Access Compliance Report Public Rights-of-Way (Pedestrian Signals)

Main Street: BENJAMIN_DR Cross Street: ANTONIO_PKWY Location: NW

ADA ID: SGRK211020132935 Signal Type: One Push Button-Non APS Overall Compliance: No Severity Scores: BTN 1: 20 BTN 2: N/A No BTN: N/A

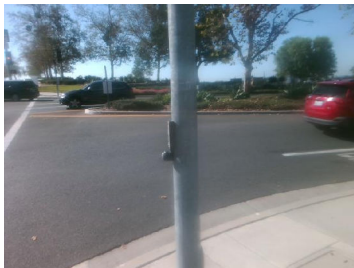
OC Std/PROW: R209.1, MUTCD 4e.08

Possible Solutions: Replace Signal Push Button With APS Button. Remove & Relocate Sign.
